Subject: RE: FW: Grove Gulch Comment Discussion and Resolution

# STATE OF MONTANA, NATURAL RESOURCE DAMAGE PROGRAM

# **MEMORANDUM**

**SUBJECT**: Comments on BPSOU Grove Gulch Submittals Received from British Petroleum

Figure 3: Waste Characterization and Management Decision Flow Chart

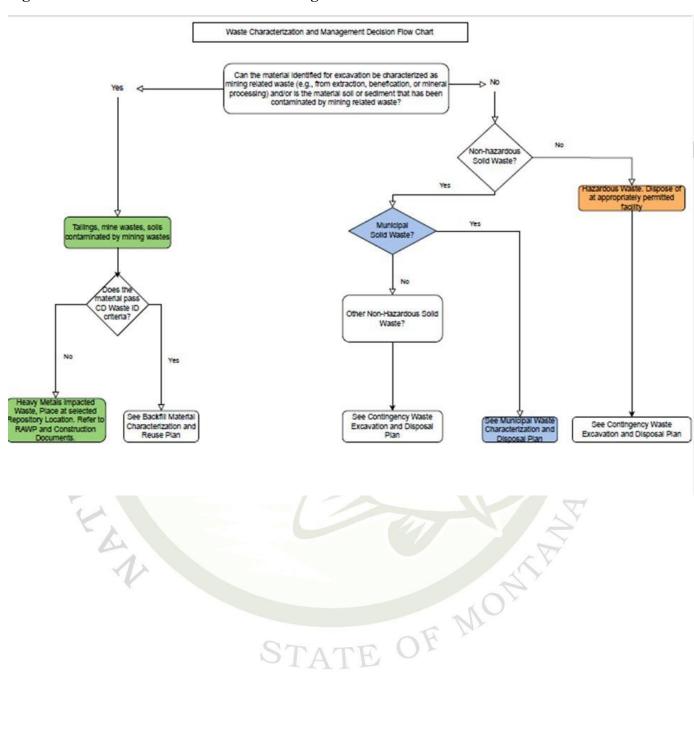
# 2. Figure 3: Waste Characterization and Management Decision Flow Chart (Attachment B)

This decision tree does not explain how "material" will be "identified for excavation." Is it implied that they will be visually identified? Will they be identified by utilizing Figure 2? Contaminants cannot be identified by visual or accurately predicted by modeling without statistically determined confidence intervals.

EPA added this comment.
